TITLE : AIR CONDITIONING – COCKPIT AND CABIN TEMPERATURE CONTROL – RELOCATE
COCKPIT TEMPERATURE REGULATION SENSOR.

This page transmits Revision No. 02 of Service Bulletin No. A320-21-1112

SERVICE BULLETIN No. : A320-21-1112

REVISION No. : 02 – Dec 21/00

Figure 4 Sheet 1
Modification to the Equipment in the Cockpit (Config. 01 and Config. 02)

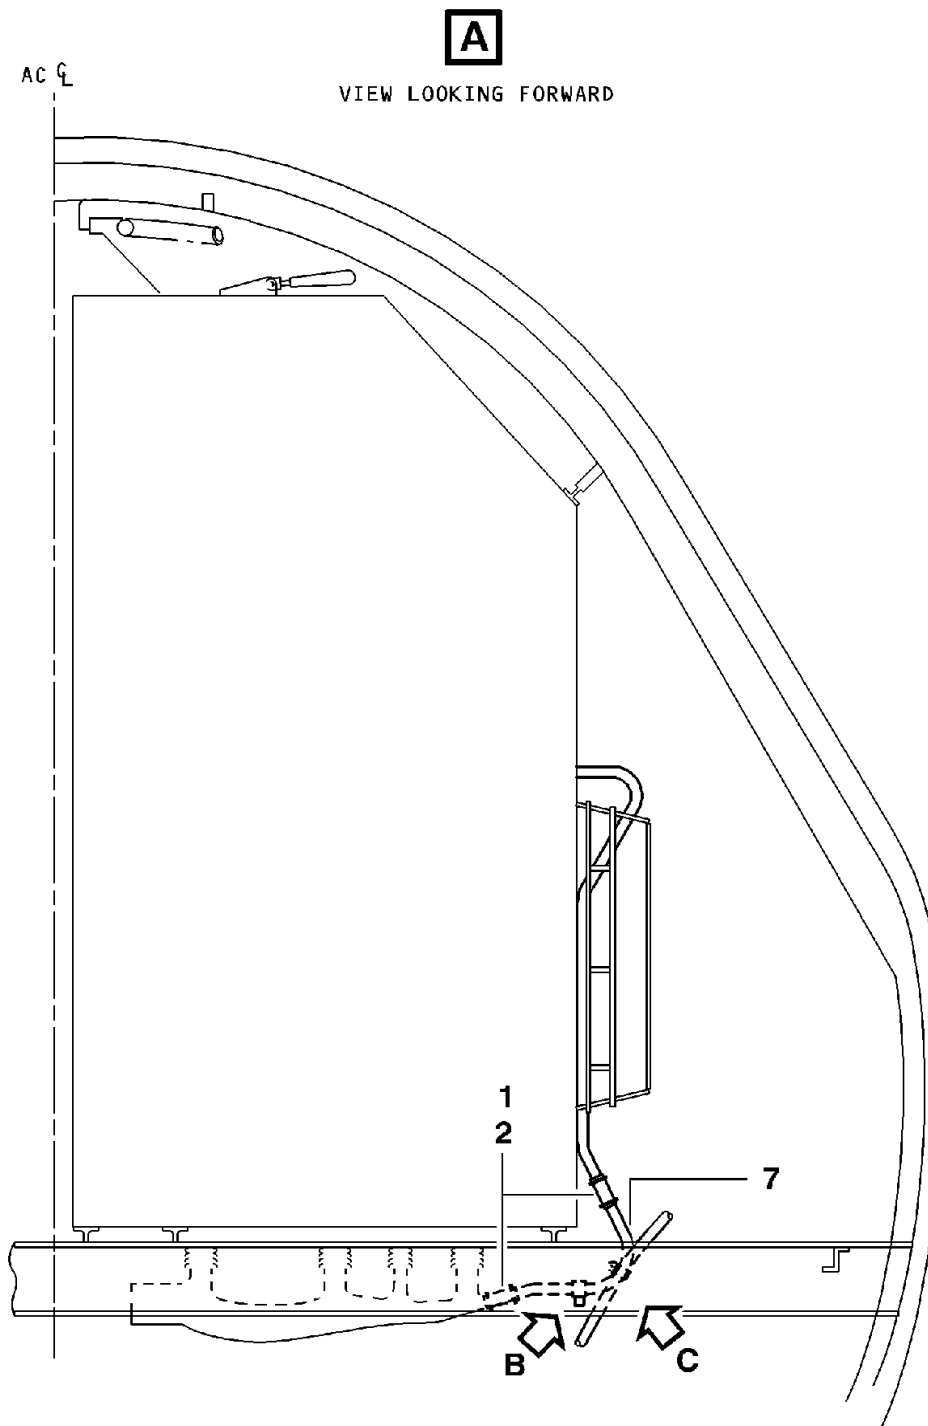
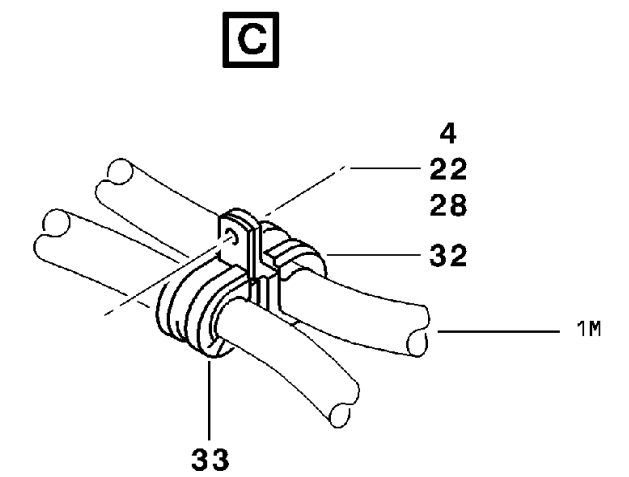
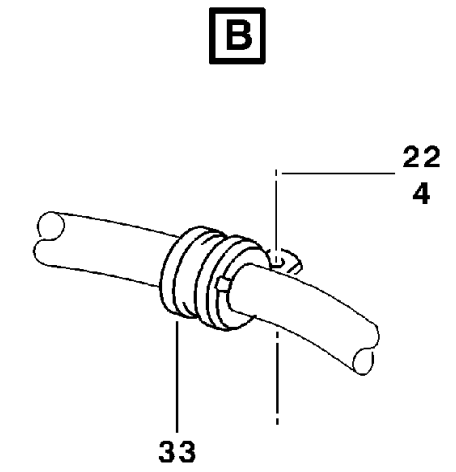
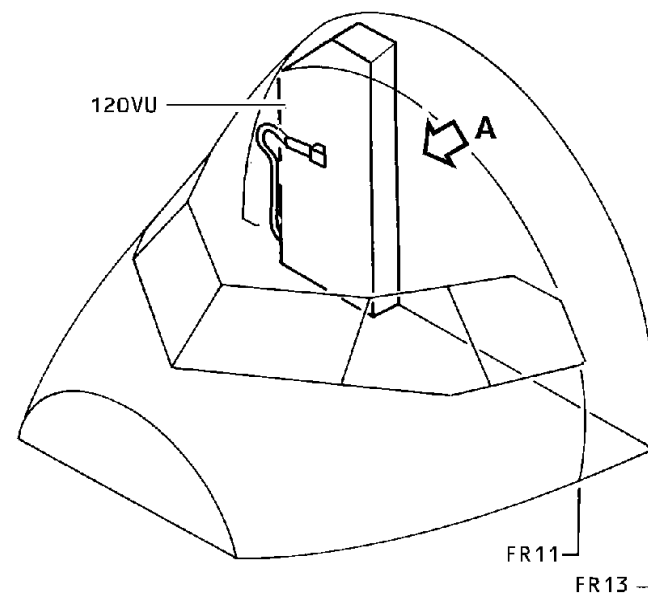
9 Install :
Refer to figure 4

Figure 7 Sheet 1
Modification to the Equipment in the Rear Panel 120VU (Config. 01)

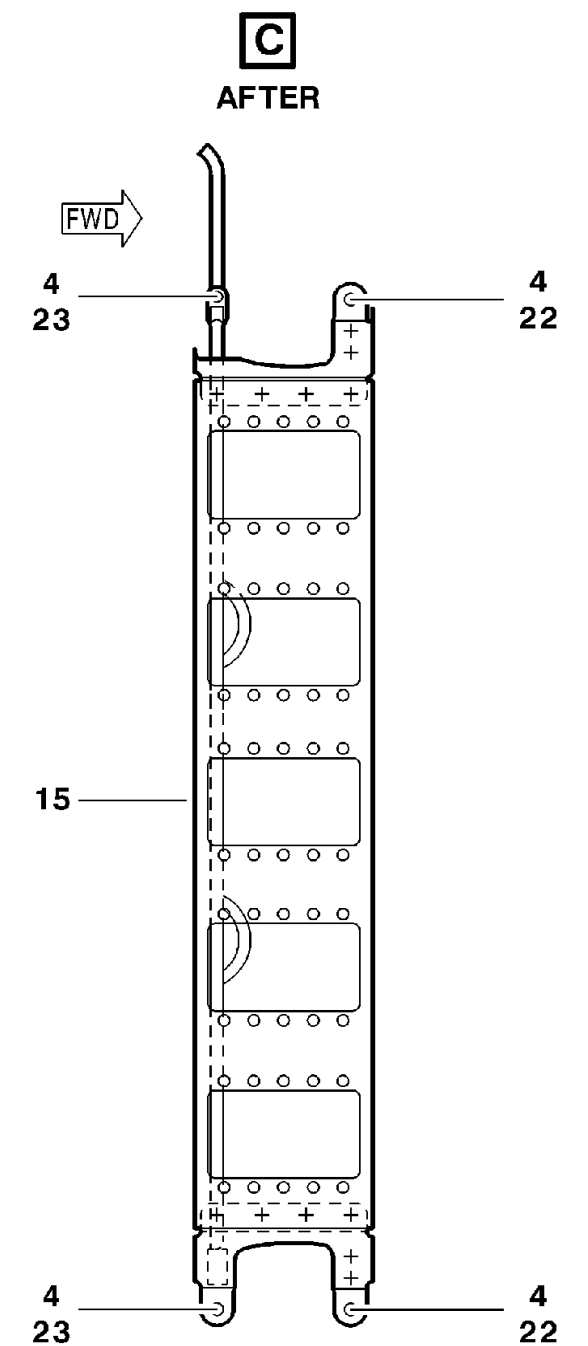
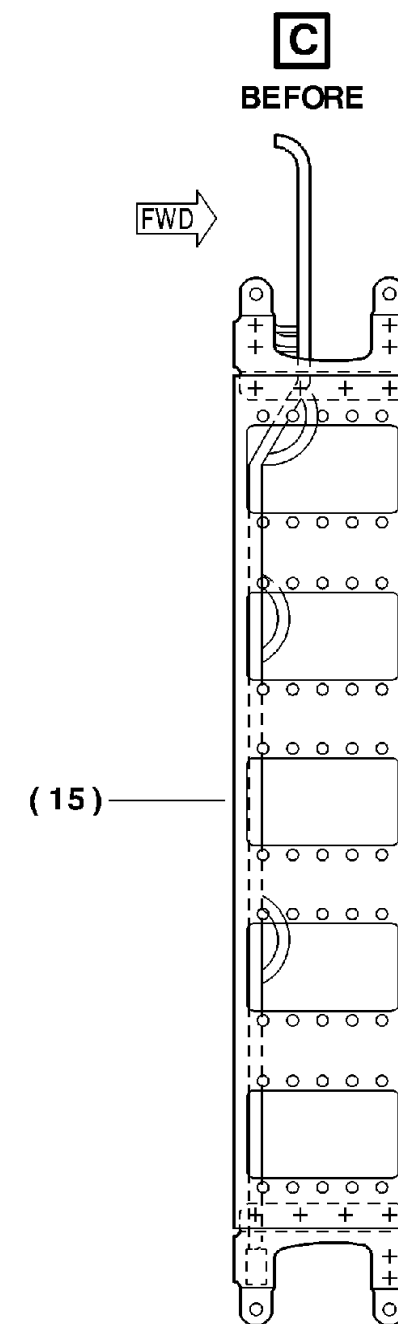
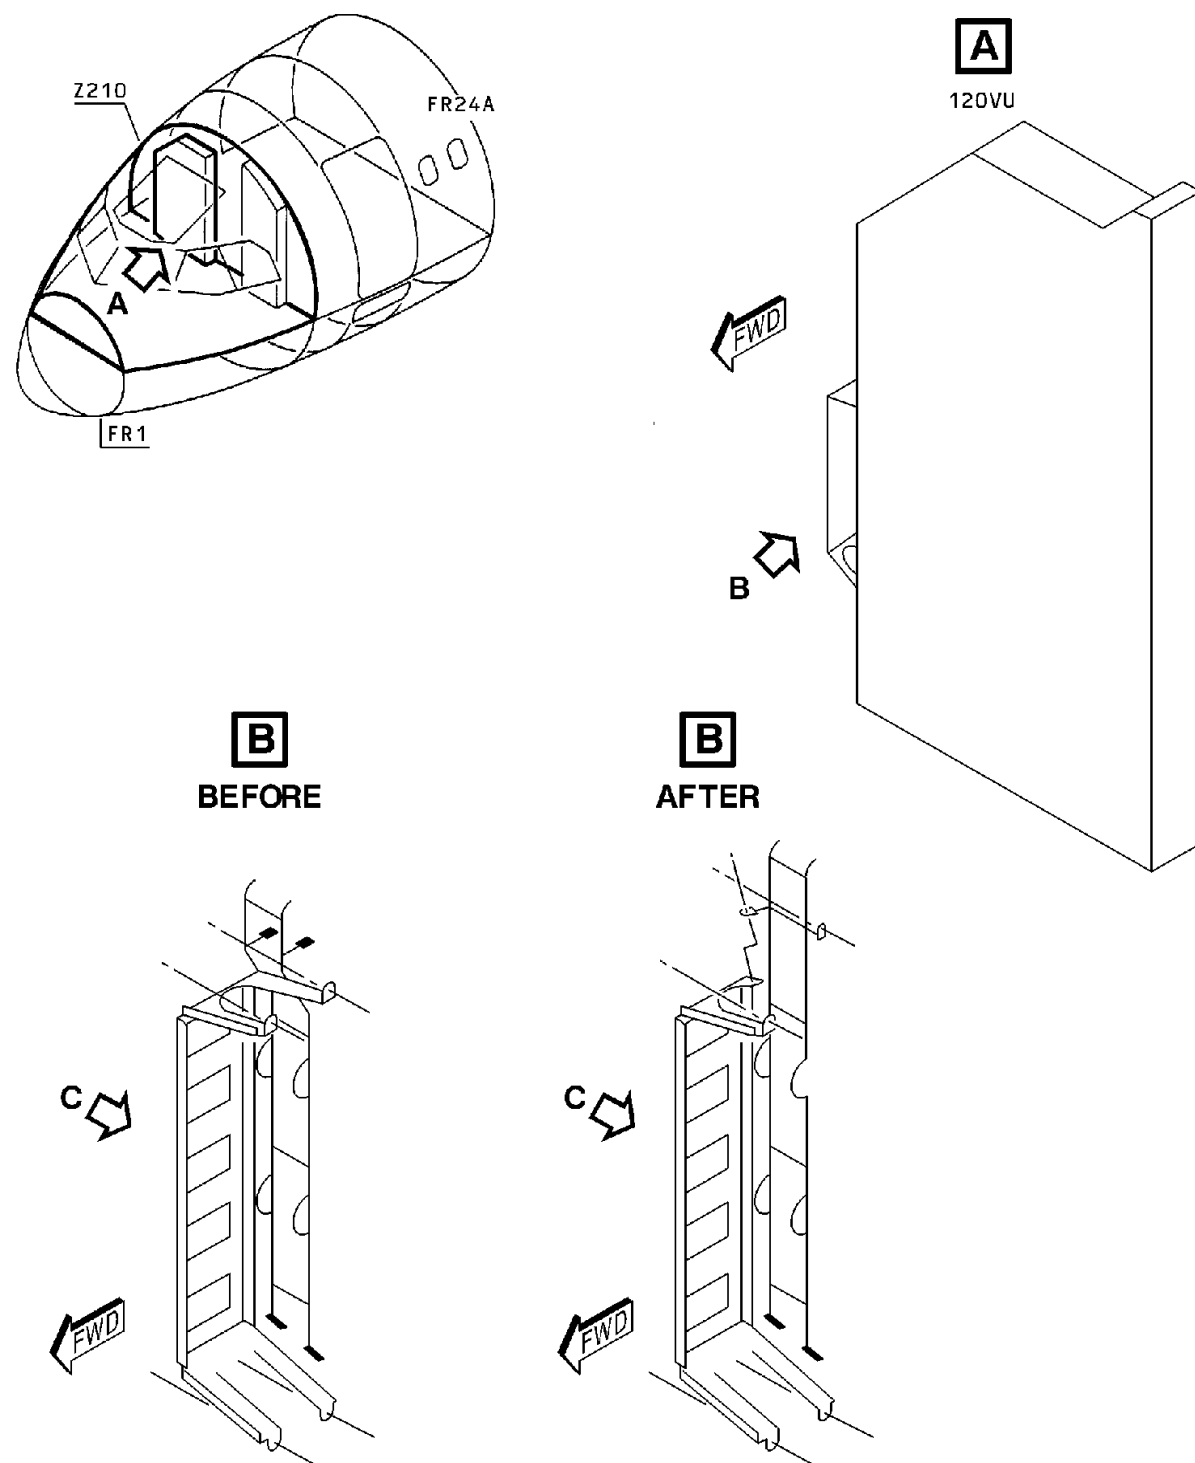
6 From the plate assy, Item (15), remove and stow all the connectors and receptacles (Refer to figure 7).

7 Remove :
Refer to figure 7

6 Install :
Refer to figure 7

Figure 12 Sheet 1
Modification to the Equipment in the Rear Panel 120VU (Config. 01)

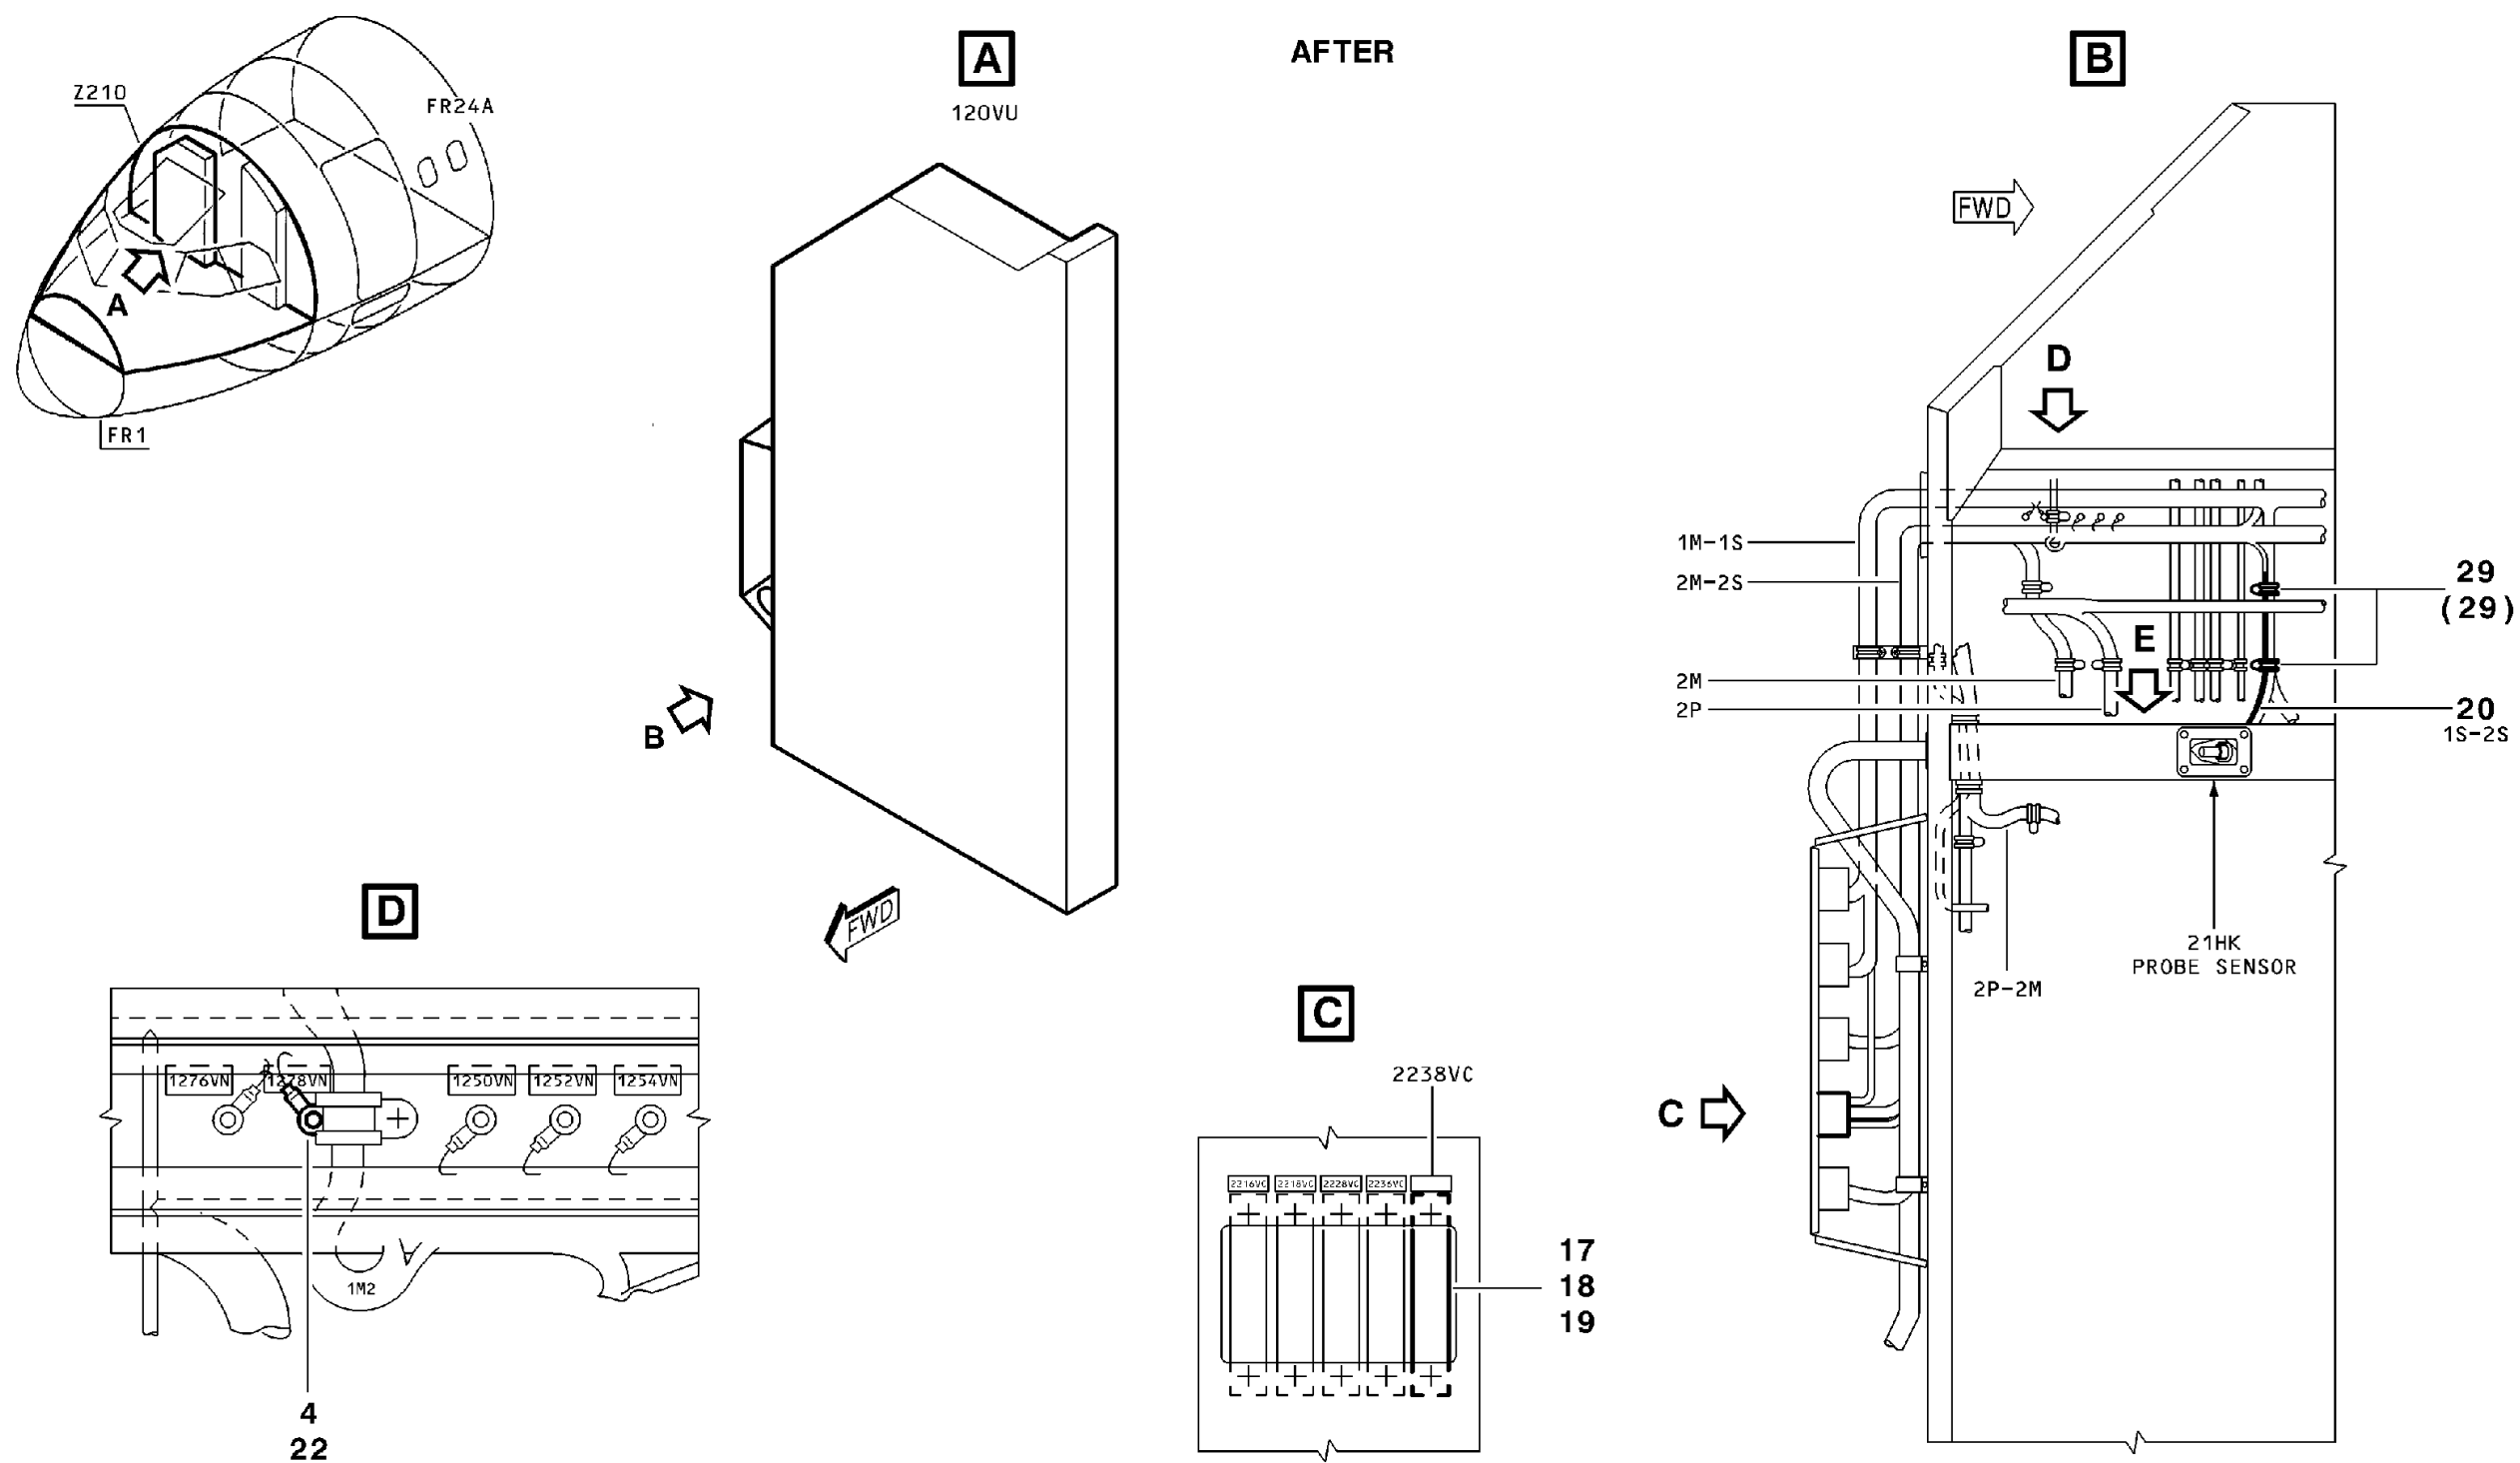
1 From the routing 1M, remove :
Refer to figure 12

2 From the routings 2M and 2P, remove :
Refer to figure 12

- 9 On the routing 1M, install :
Refer to figure 12

- 10 On the routings 2M and 2P, install :
Refer to figure 12

Figure 13 Sheet 1
Modification to the Equipment in the Cockpit

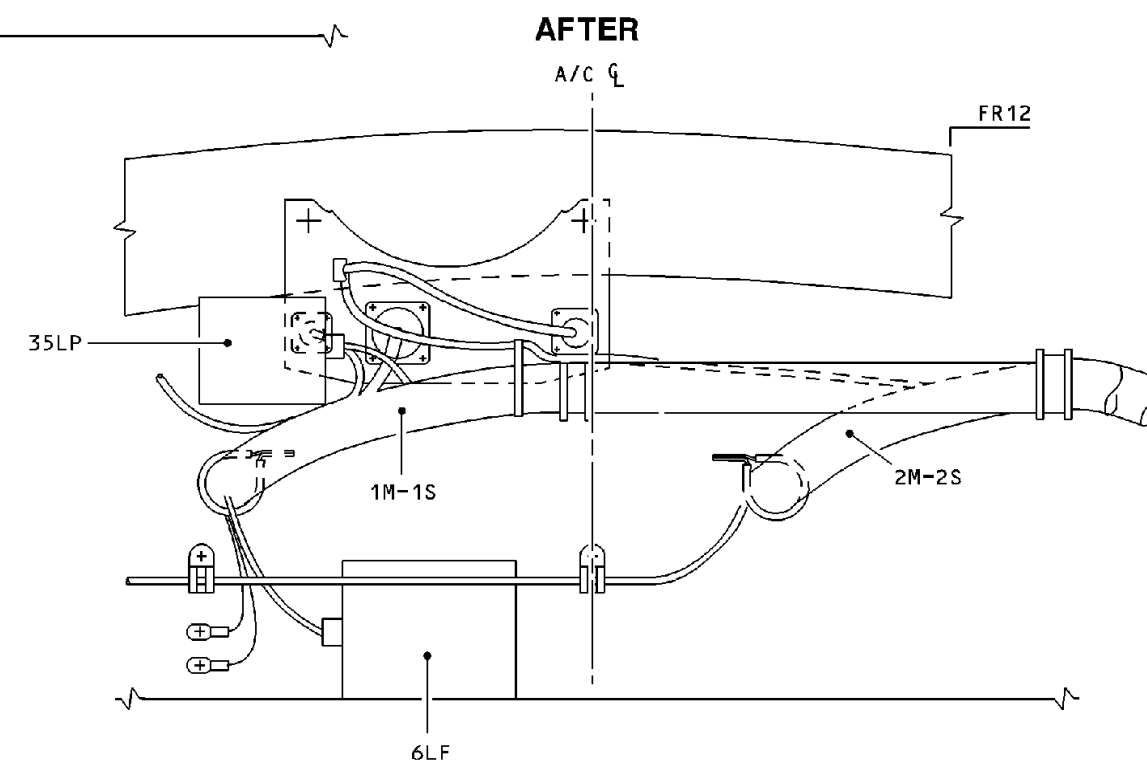
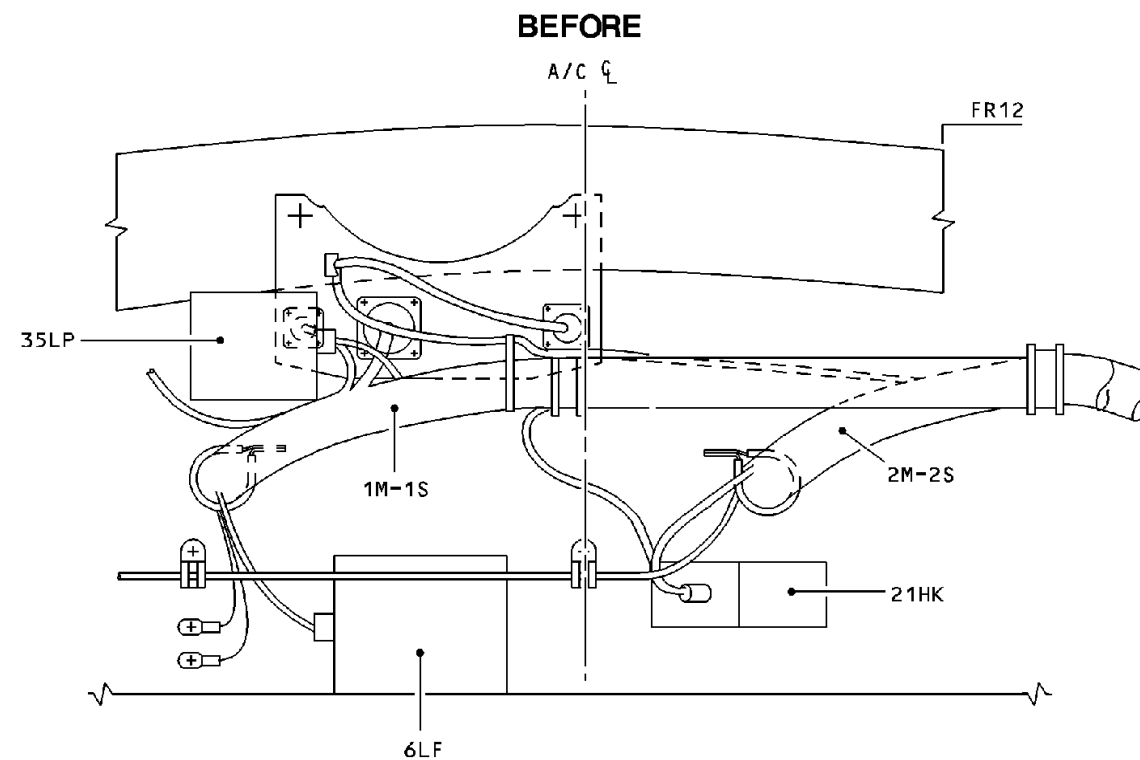
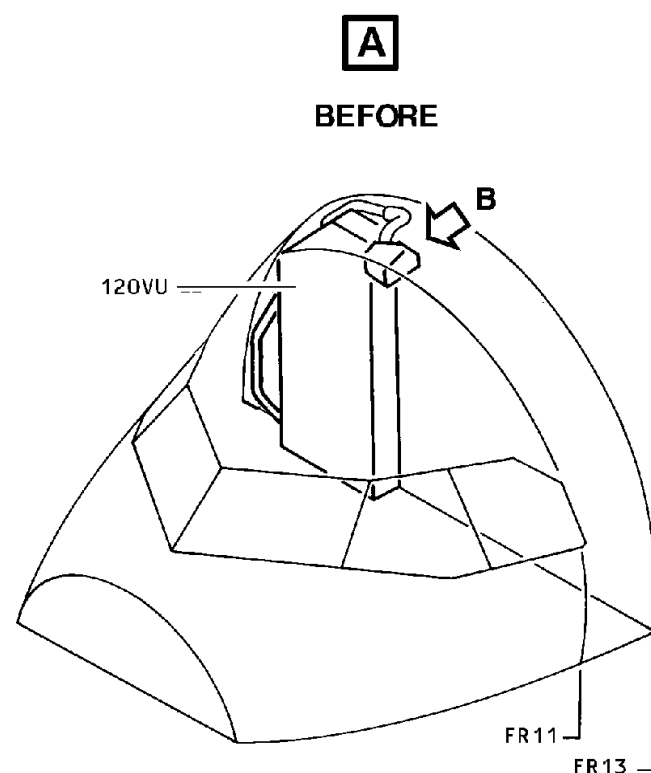
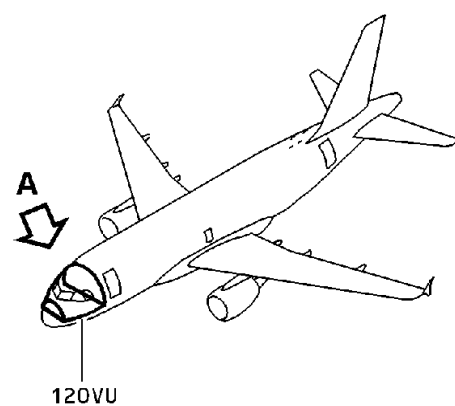
1	Panel	Item (13)	Discard
---	-------	-----------	---------
 - 3 Remove the wires shown on the lines 1 thru 9 (Refer to figure 25).
 - 4 Remove the connector 21HK-A
Refer to figure 13
 - 5 Install the panel 211HC :
(Refer to AMM 25-13-41 Page block 401)
Refer to figure 1
